Technical News Bulletin

Emhart Glass Releases A New Stepper Motor Drive, Replacement Kit. # 27533A For Veritas iB

Veritas iB Stepper Motor Control Panel

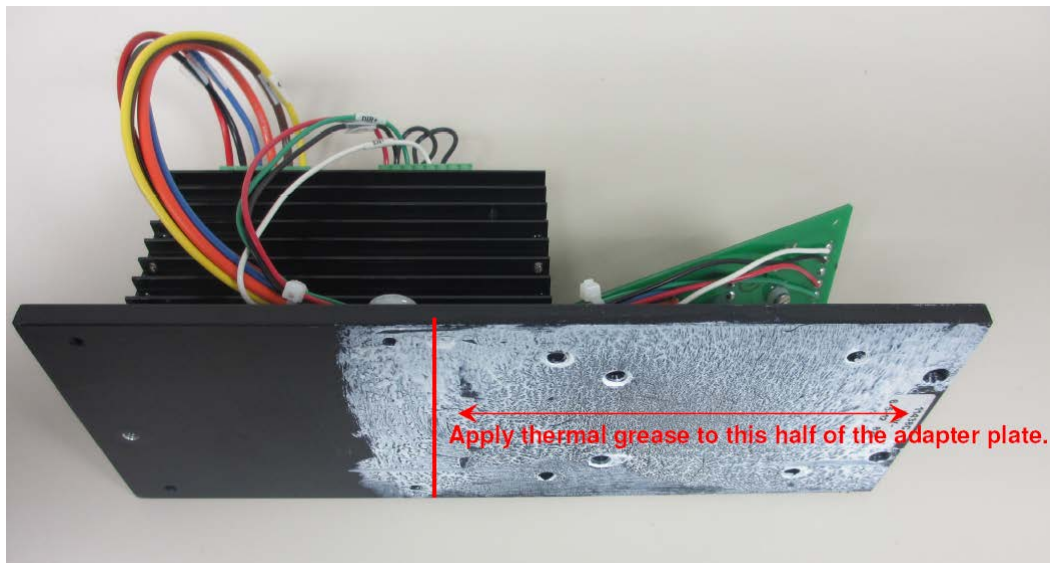
Due to part obsolescence, the IB106 Stepper Driver (12706P) for the Veritas iB belt handler will no longer be available and will be replaced with update kit # 27533A when needed.

Stepper Motor Replacement Kit #27533A Includes:

- Qty. 1 - Configured Stepper Drive Part # 21817B
- Qty. 1 - Adapter cable and PCB
- Qty. 1 - Adapter Plate
- Qty. 1 pack - Thermal Grease

Installation of the parts in the new kit was designed to be simple and does not require Emhart Glass service personnel to do the installation. To install, the adapter plate mounts directly to existing holes in the back panel and the pins on the printed circuit board plug directly into the 17800 stepper control board. Detailed mounting instructions for installation of the new replacement parts will be included in each kit.
